CHANGE ORDER

<input checked="" type="checkbox"/> ORDERED BY ENGINEER UNDER SECTION 1-04.4 OF THE STANDARD SPECIFICATIONS. <input type="checkbox"/> CHANGE PROPOSED BY CONTRACTOR	PROJECT IDENTIFICATION PROJECT NAME: 36 th Avenue W & 35 th Avenue W, 164 th St SW to SR 99 PROJECT NUMBER: RC1783, RC1784, RR6337, RR6342, UPI 06-0014 Fed Aid #: STBGUL-2585(001)
CONTRACTOR ENDORSEMENT:	CONTRACTOR: Marshbank Construction, Inc.
<div style="display: flex; justify-content: space-between;"> <div>SIGNATURE</div> <div>DATE</div> </div>	ADDRESS: PO Box 97 3304 Old Hartford Rd Lake Stevens, WA 98258
<div style="text-align: center;">TITLE</div>

This Change Order compensates the Contractor for added work to construct an extension of the AWWD Communication Duct bank as shown on the revised attached plan sheets AW11-AW12 with revisions dated 9/19/24. This duct bank will begin at 151st Pl SW and continue north to their new Operations Center Headquarters at 14807 Hwy 99 S.

36TH AVE W & 35TH AVE W 164TH ST. SW TO 148TH ST. SW STA 98+50 TO 103+00 UTILITY INFORMATION PLAN	REFERENCE SHEET NO. AW10 SHEET 10 OF 14 SHEETS
--	---

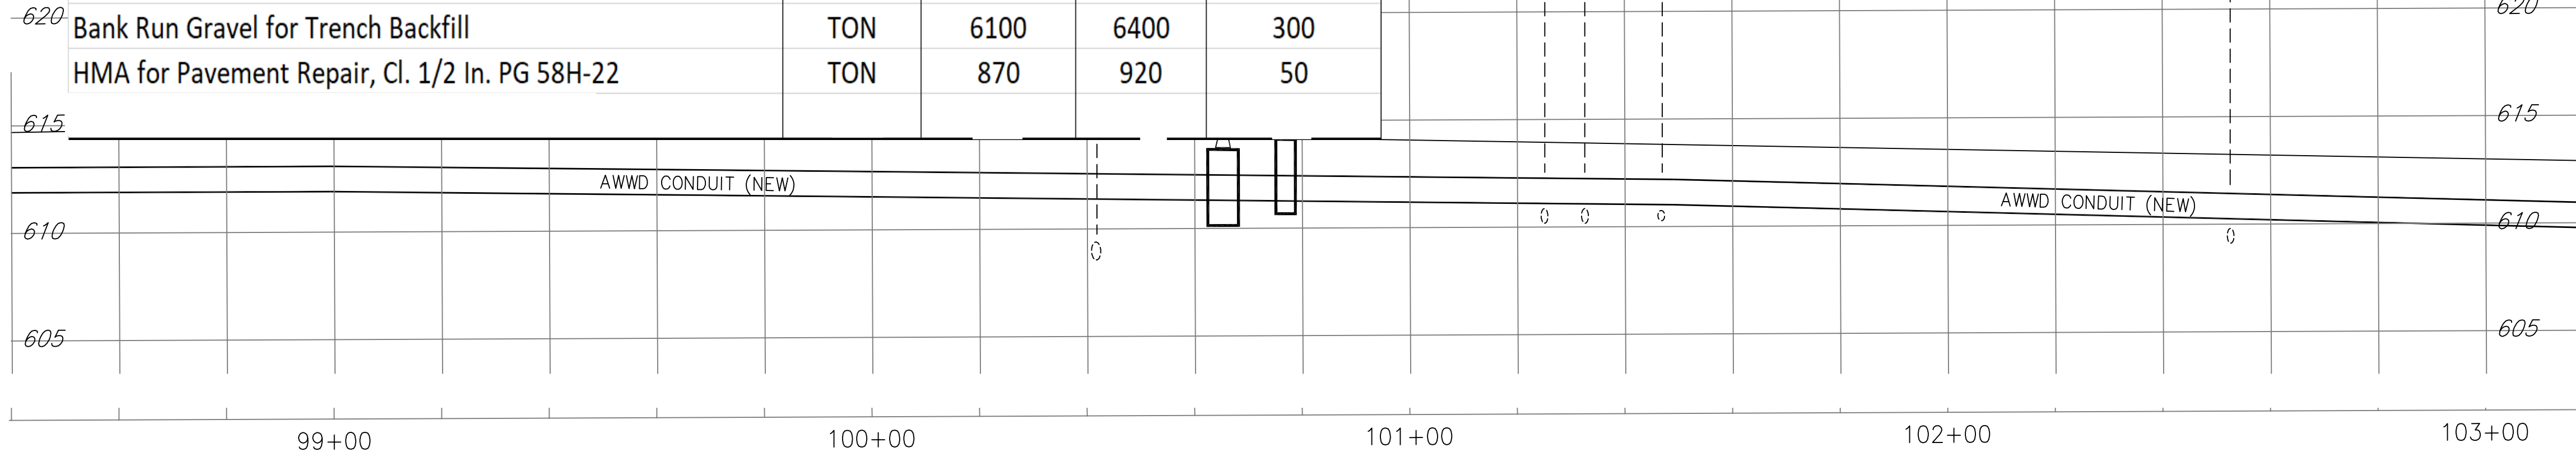
CO 1: Triple Conduit
here instead of single

RCO #1				
	Unit	Original QTY	New QTY	Delta
AWWD Single Conduit Duct Bank	LF	610	270	-340
AWWD Triple Conduit Duct Bank	LF	2000	2770	770
AWWD Conduit Pull Box	EACH	3	3	0
AWWD Conduit Junction Box	EACH	6	7	1
Bank Run Gravel for Trench Backfill	TON	6100	6400	300
HMA for Pavement Repair, Cl. 1/2 In. PG 58H-22	TON	870	920	50

REFERENCE SHEET NO. AW11
SHEET 11 OF 14 SHEETS

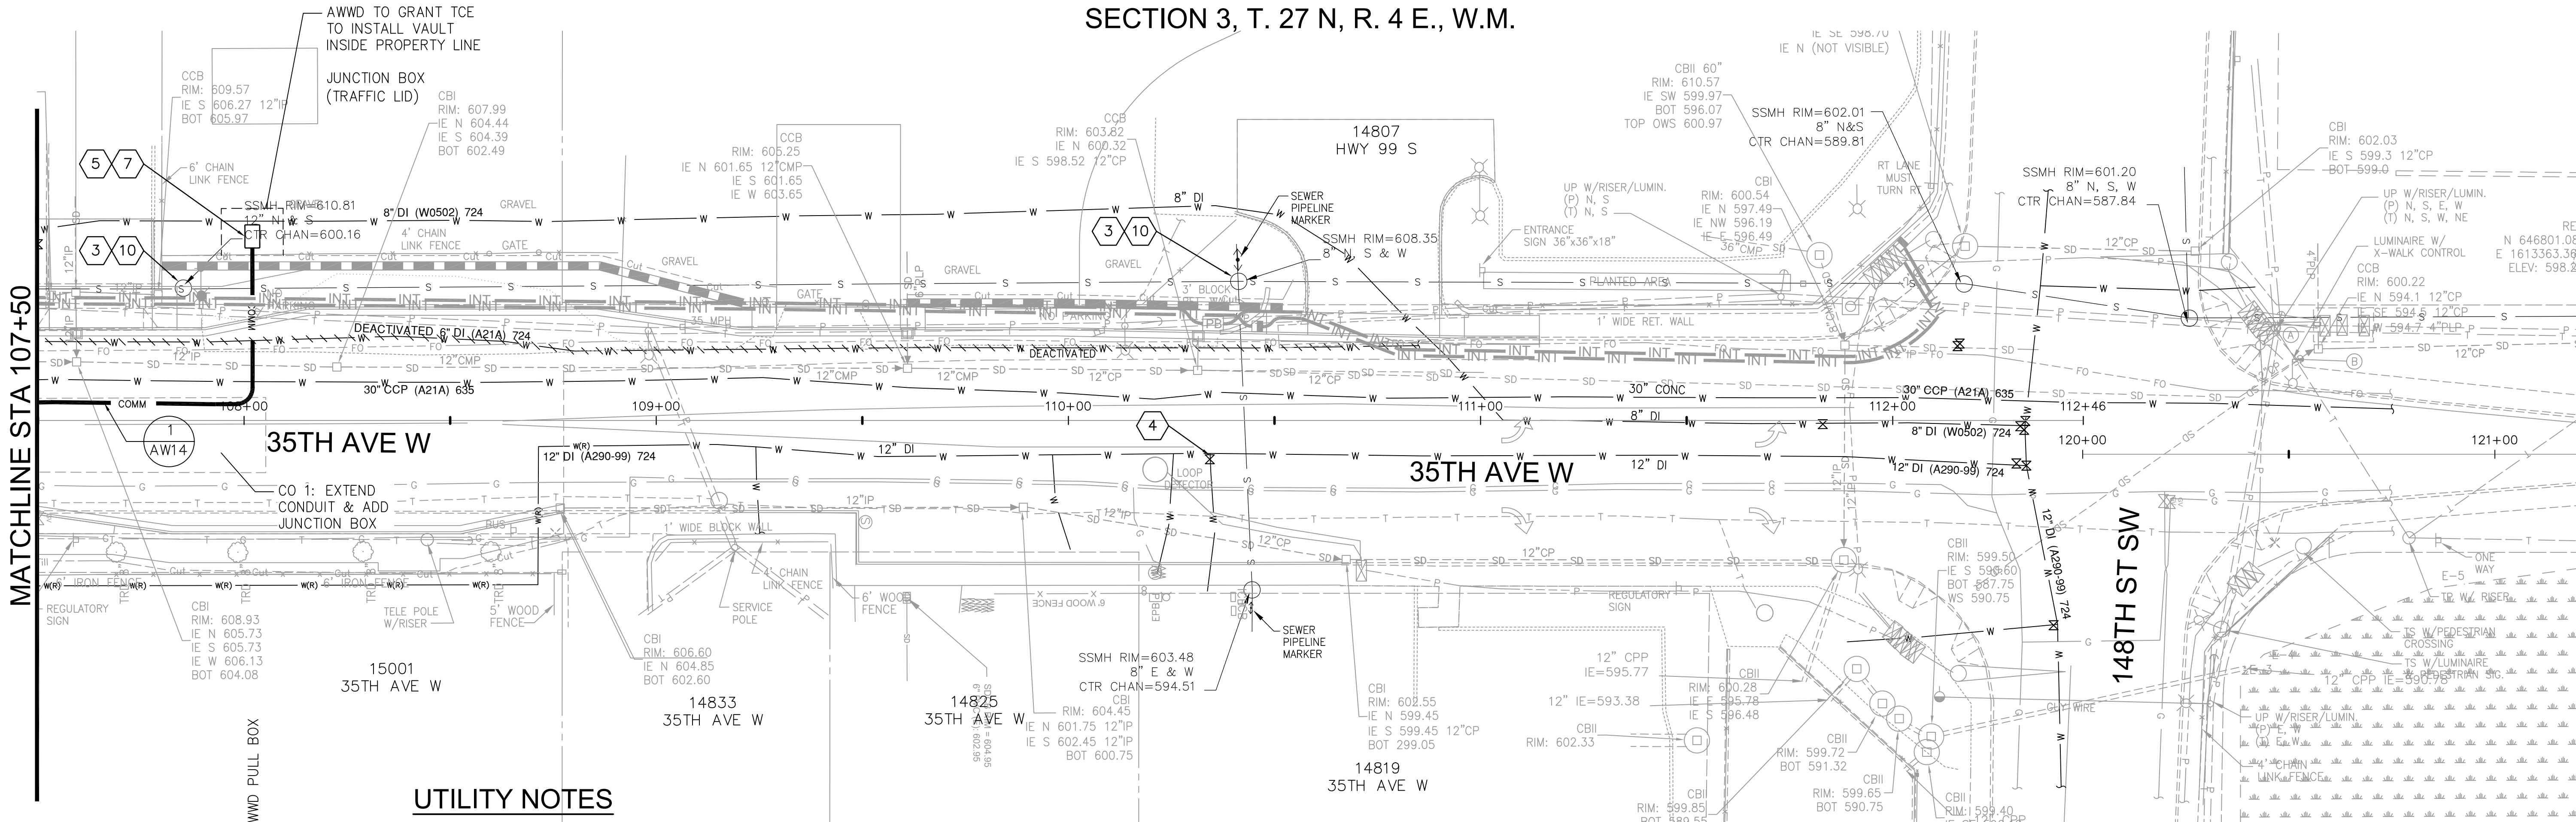
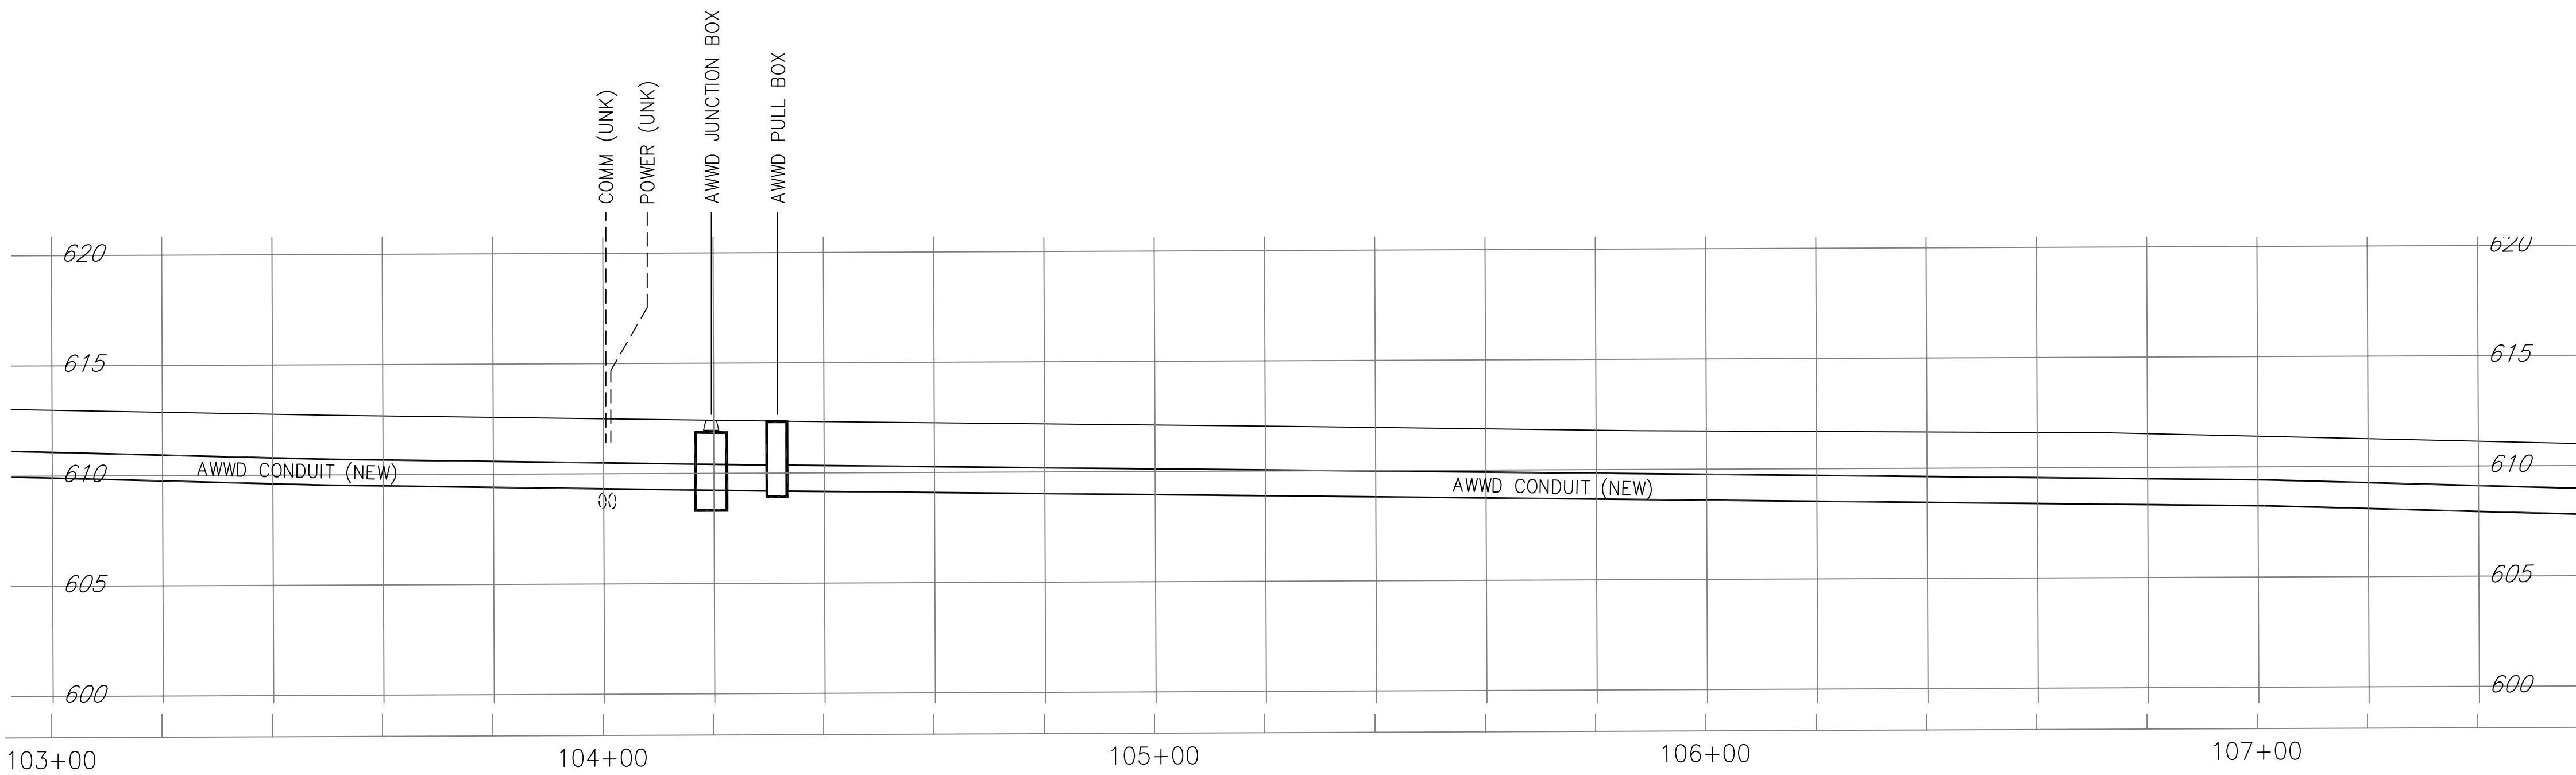
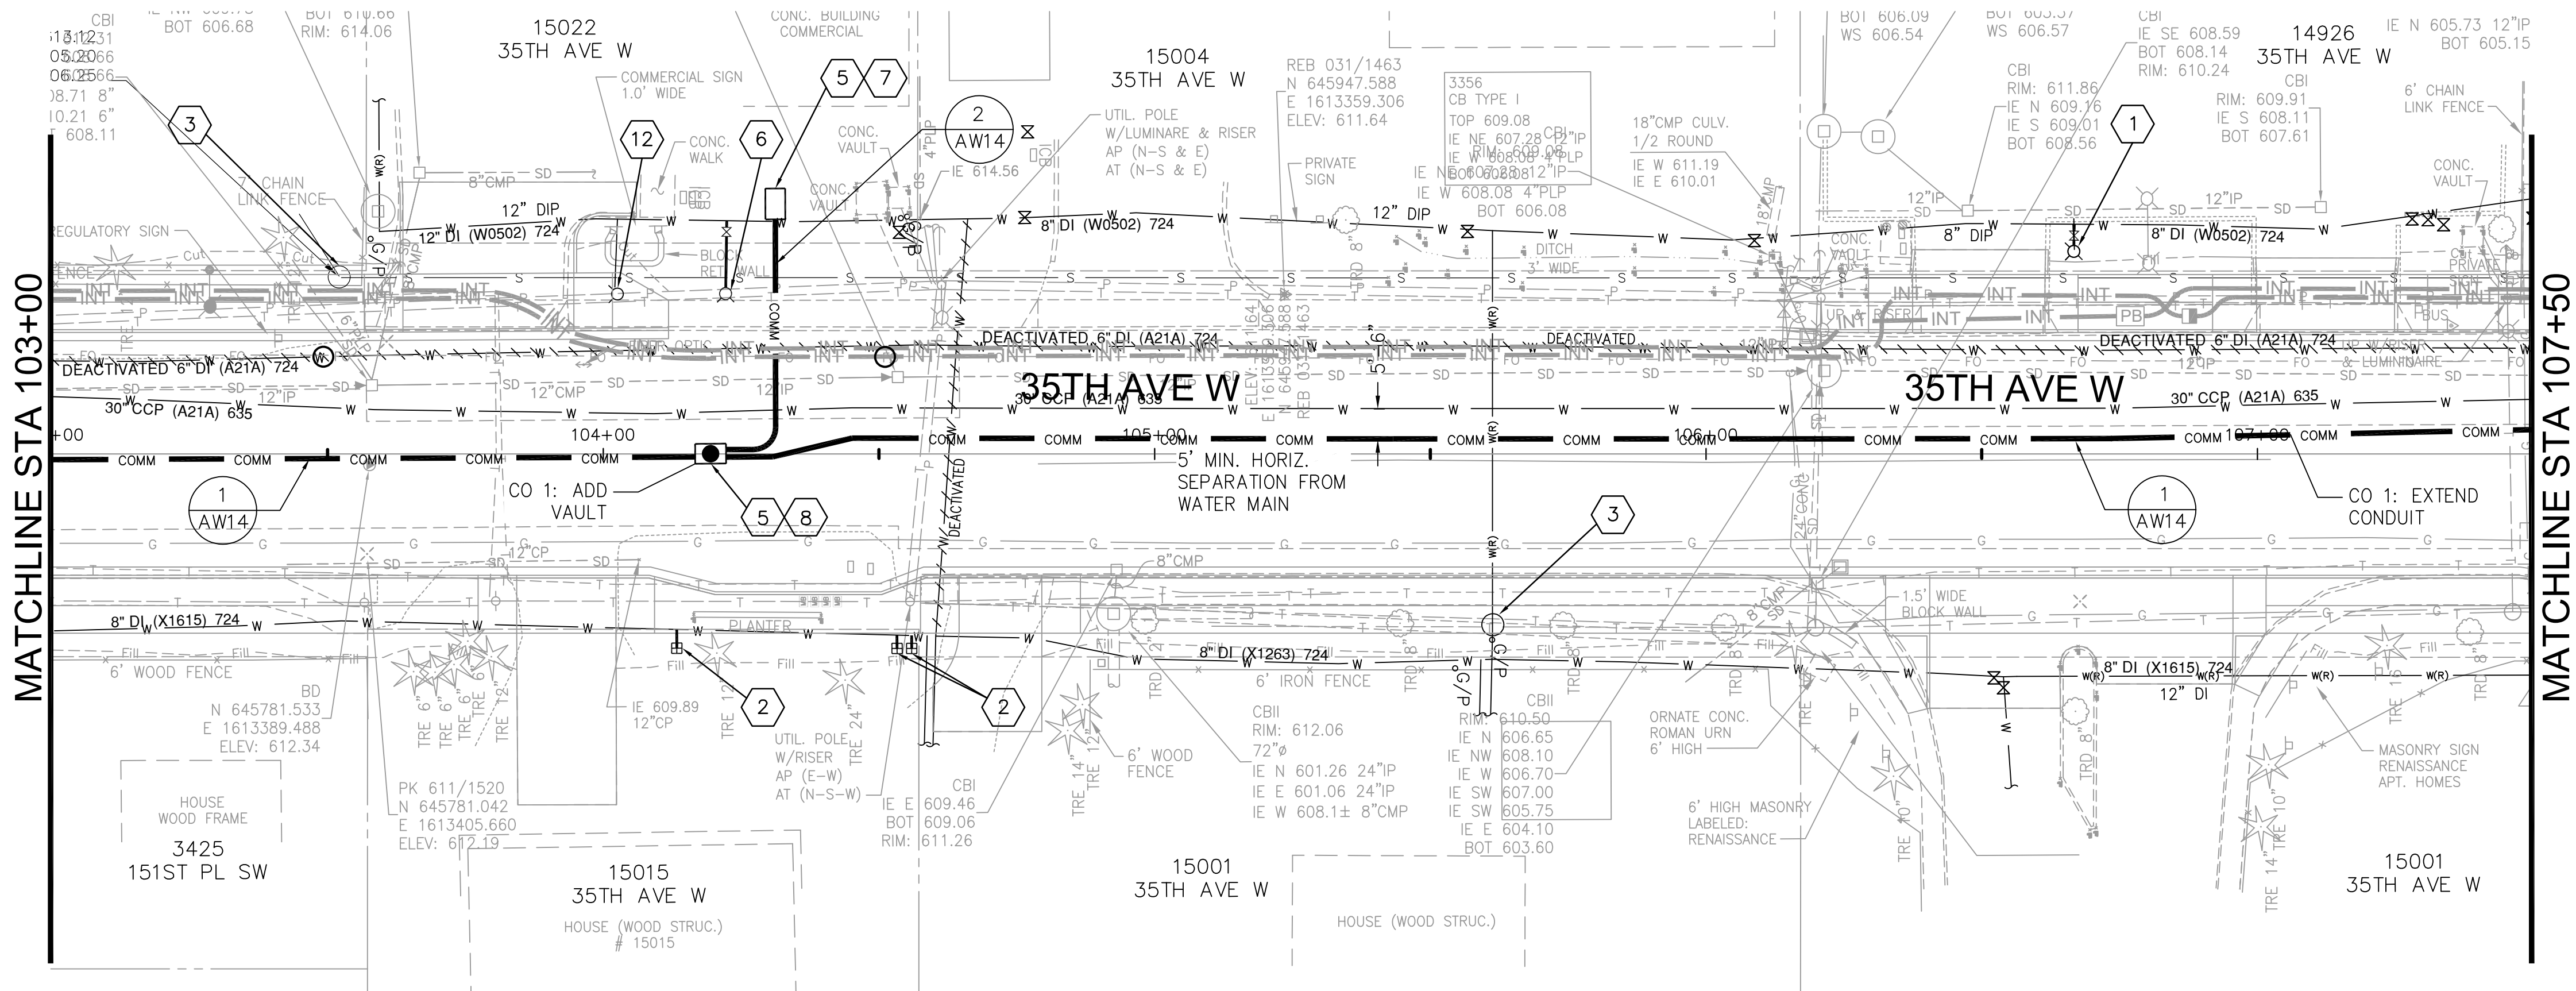
8/9/24	TRIPLE CONDUIT / MODIFY INJECTION VAULT	BJG	LCM
9/19/24	WATER / COMM CONDUIT REALIGNMENT	BJG	LCM
Change Order #5 12/9/2024 Page 4 of 6			
DATE	NO.	REVISION	BY

REFERENCE SHEET NO. AW12
SHEET 12 OF 14 SHEETS

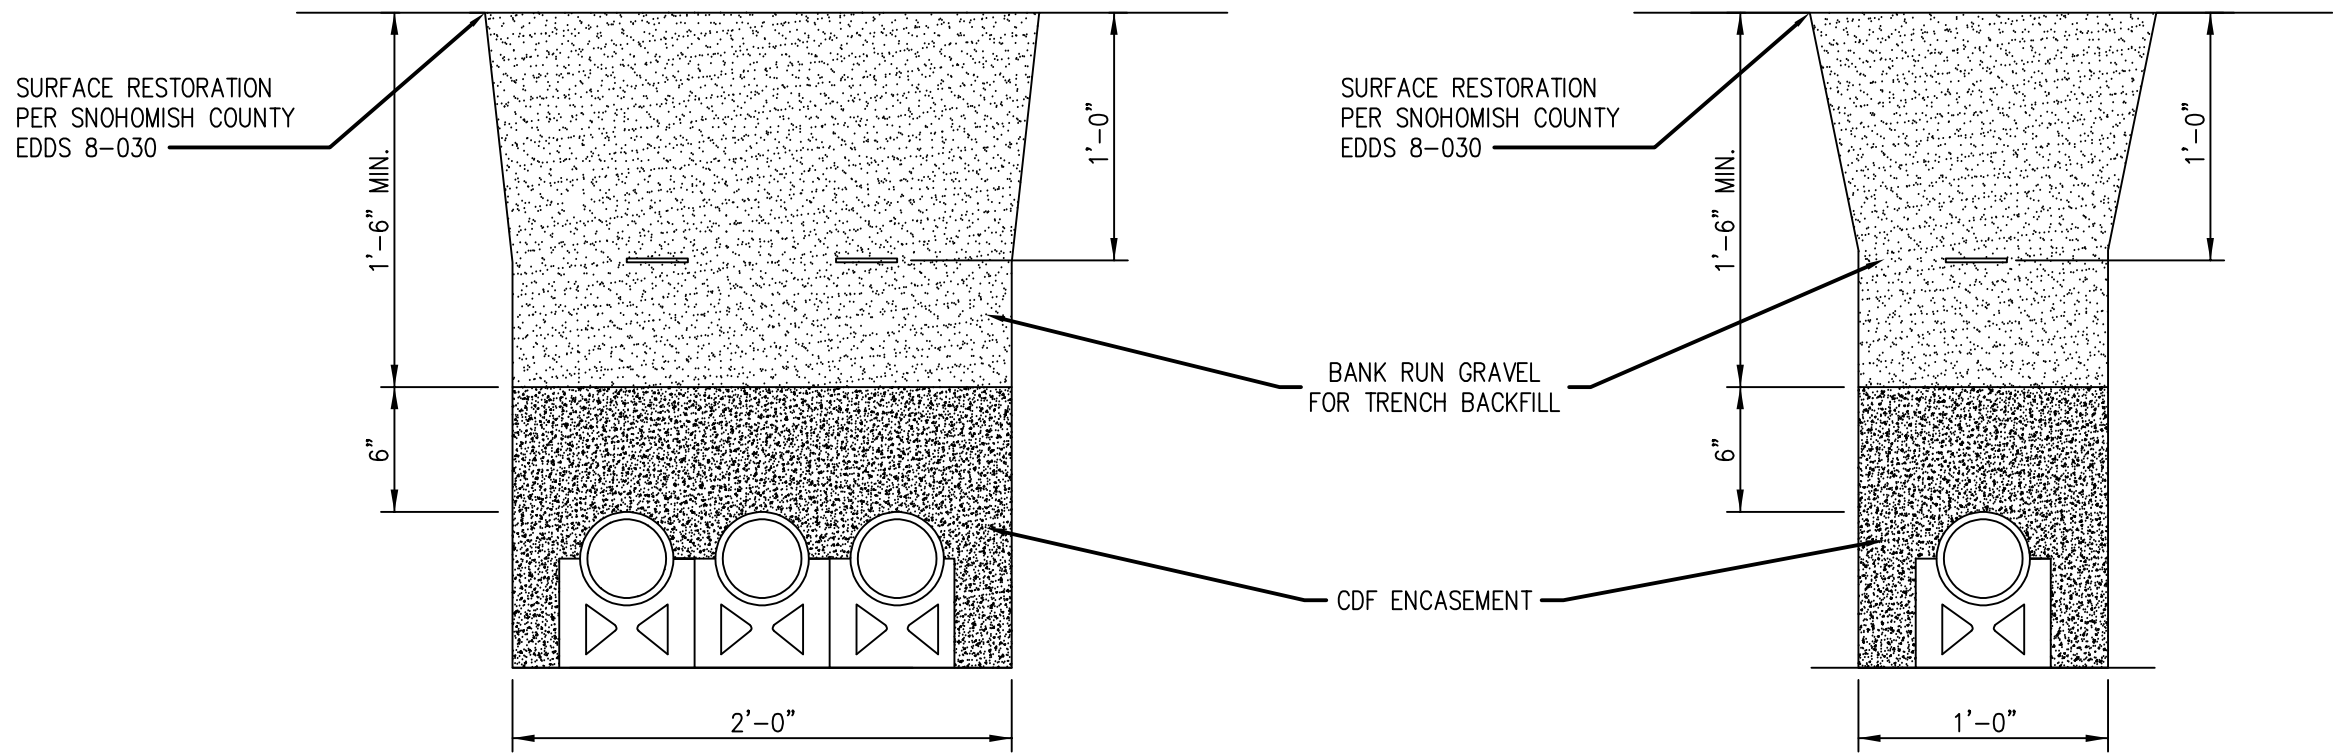
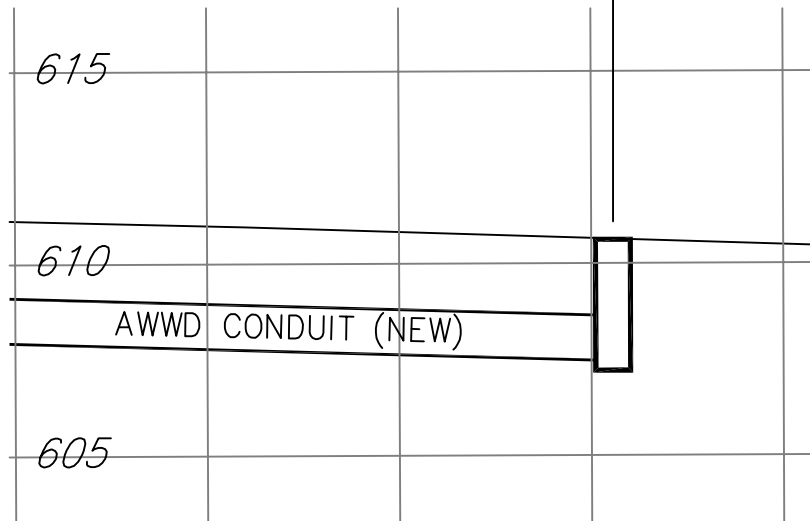
8/9/24	1	TRIPLE CONDUIT / MODIFY INJECTION VAULT	BJG	LCM
9/19/24	2	WATER / COMM CONDUIT REALIGNMENT	BJG	LCM
Change Order #5 12/9/2024 Page 5 of 6				
DATE	NO.	REVISION	BY
